**RE: Grading and Drainage Plan for Hinman Residence, Lot 24, Block 10, Tract 2, Unit 1, NAA (C22/D42) (PWD-98-154) Submitted for Building Permit Approval, Engineer's Stamp Dated 10/1/98.**

**RE: Grading and Drainage Plan for Hinman Residence, Lot 24, Block 10, Tract 2, Unit 1, NAA (C22/D42) (PWD-98-154) Submitted for Building Permit Approval, Engineer's Stamp Dated 8/19/98.**

RE: GRADING AND DRAINAGE PLAN FOR LOTS 9 & 24, BLOCK 10,  
TRACT 2, UNIT 1, NAA (C22/D42)(PWD-95-99) SUBMITTED FOR  
BUILDING PERMIT APPROVAL, ENGINEER'S STAMP DATED 5/26/95.

## GRADING & DRAINAGE PLAN

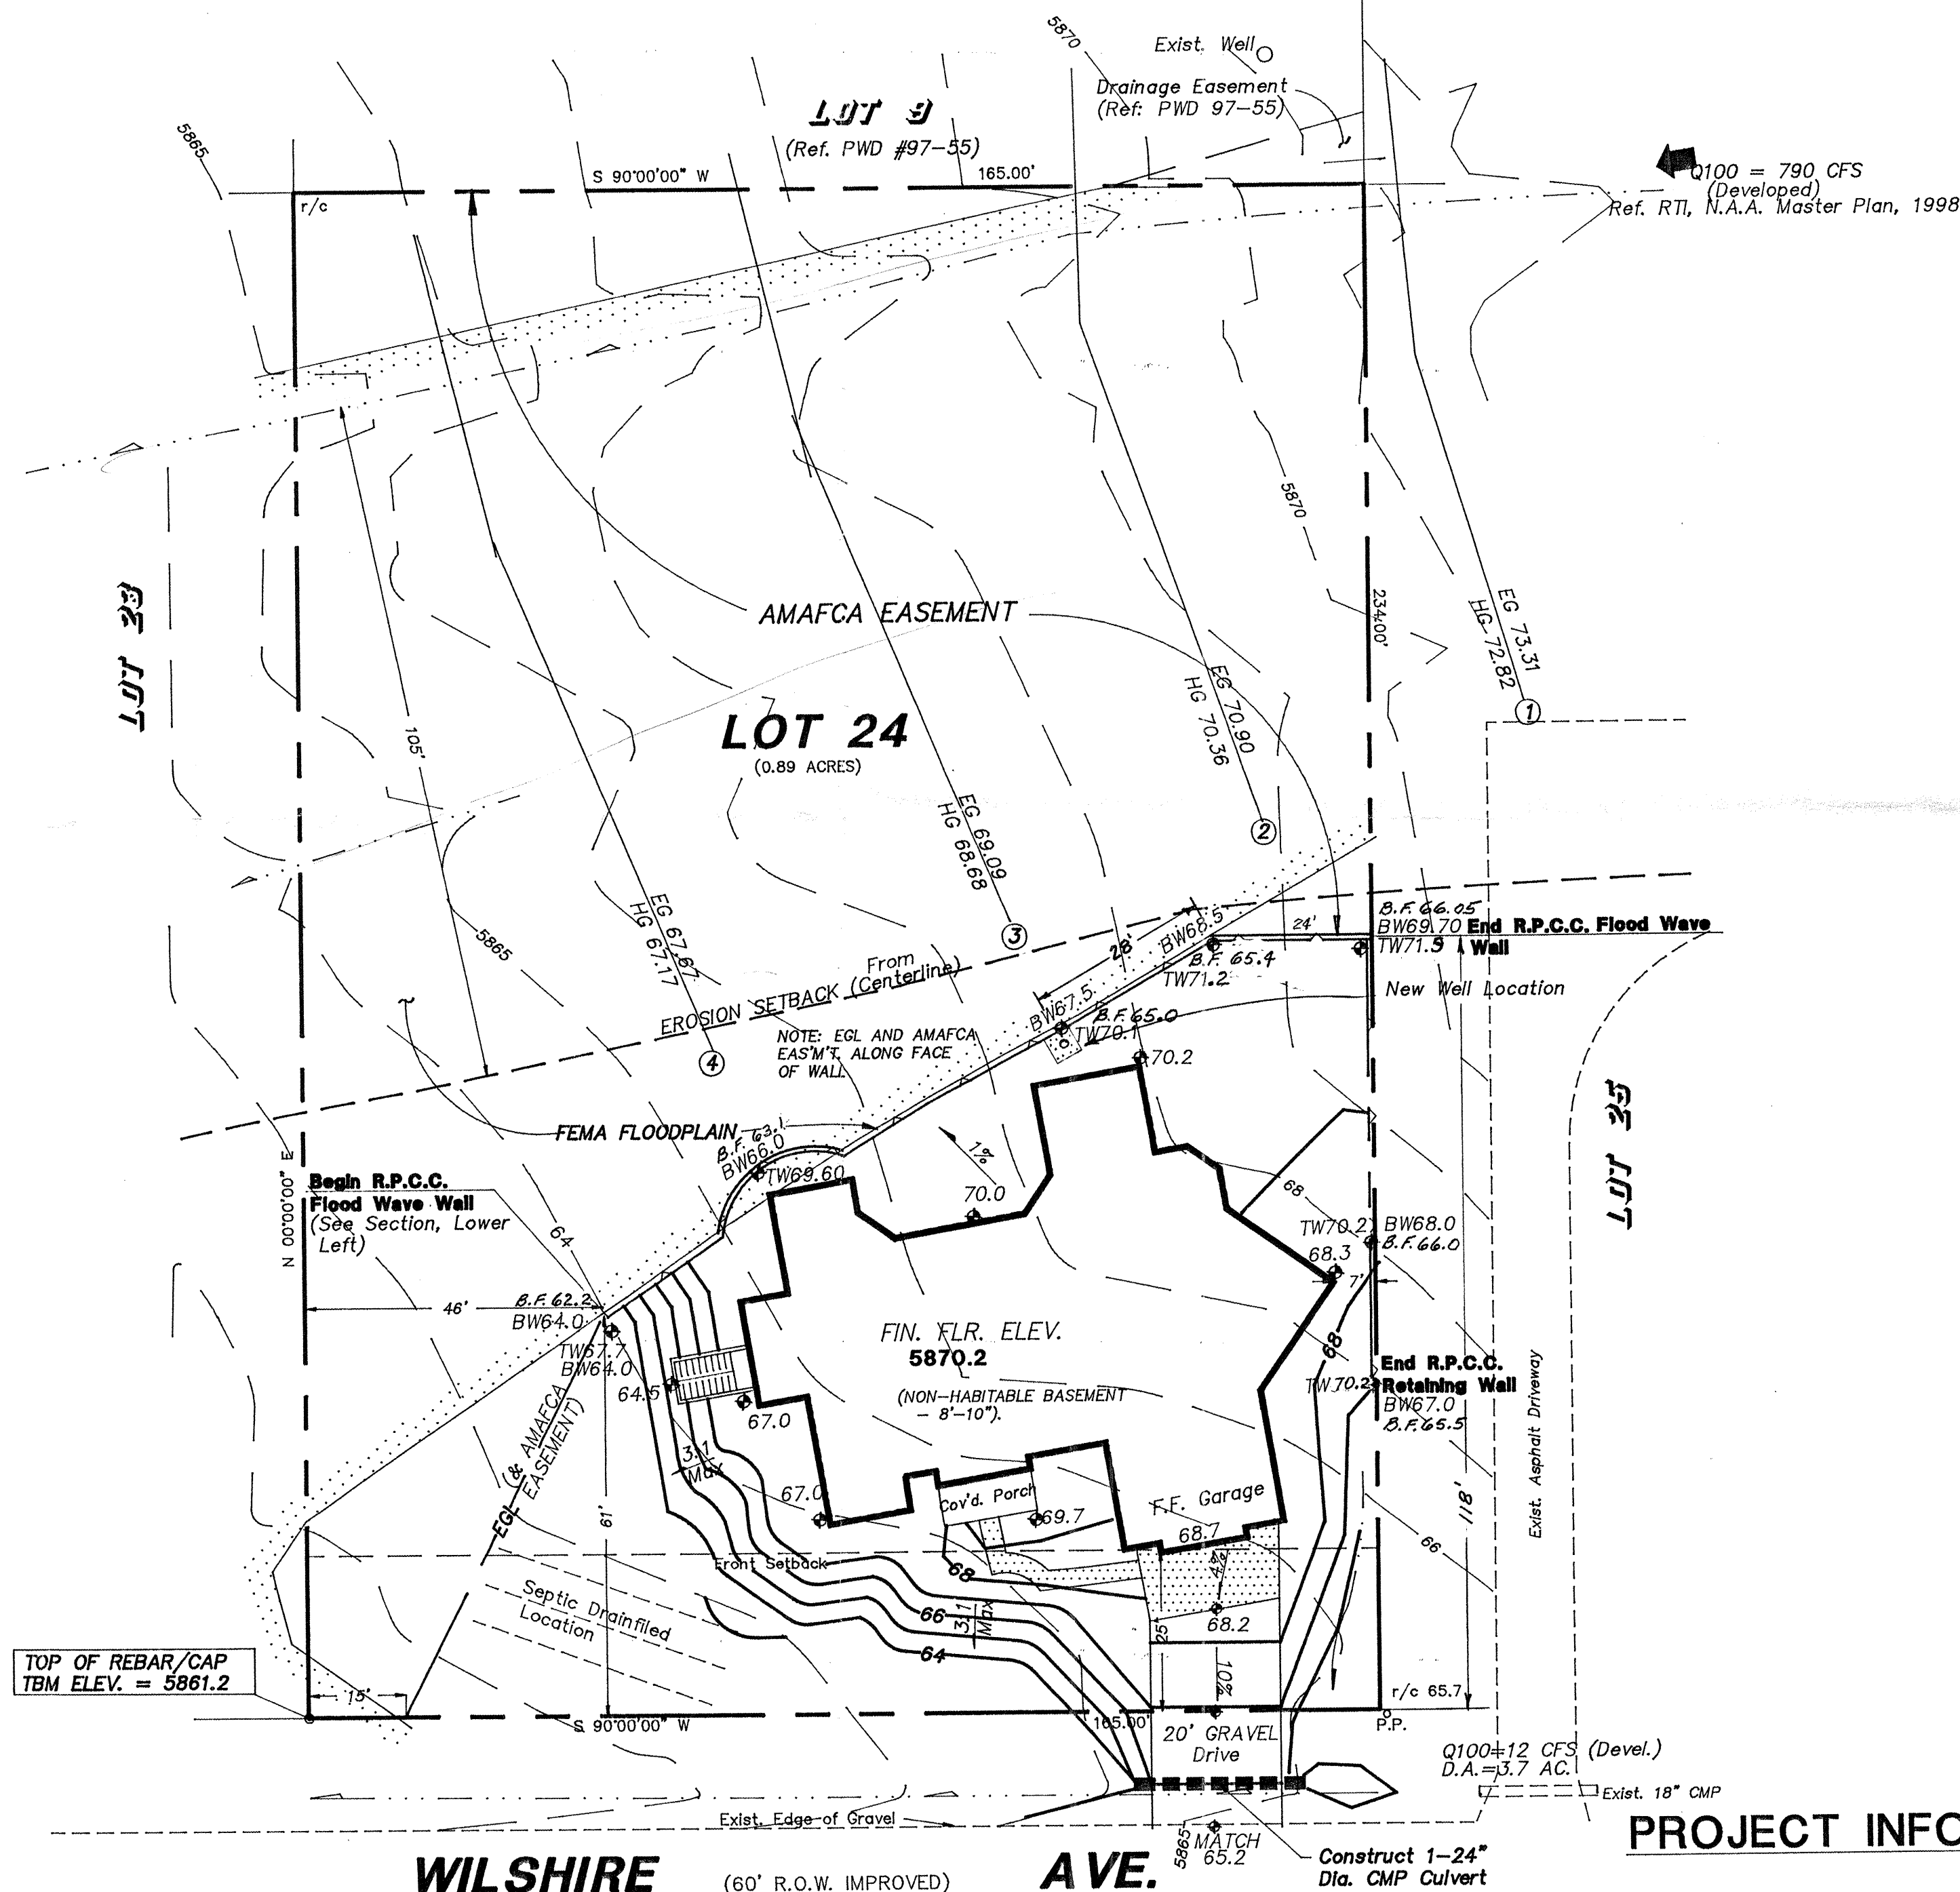
1. Please measure the erosion setback (ESB) from the centerline of the existing floodplain instead of from the northern thalweg. It does not appear that the floodplain will be confined to the north side.

2. Your plan shows a portion of the proposed flood wall within the FEMA floodplain. This wall must not encroach in the floodplain. Any alteration of the FEMA floodplain will require a Letter of Map Revision.

3. Please plot the cross-sections from your HEC-2 analyses. The HEC-2 runs indicate that some of the sections were extended vertically. Please provide more points in the sections to make sure that they can contain the runoff.

4. It appears that your energy grade line (EGL) does not "catch" without the wall. Typically the flood wall is provided to the limit of the EGL. On the upstream side, will the east side of the house be protected?

5. Are the top of wall elevations as high as the EGL plus freeboard?

6. The flood wall must be built to scour depth. Provide the scour analysis. The bottom of wall elevations must be the minimum elevation minus the scour depth for each section.
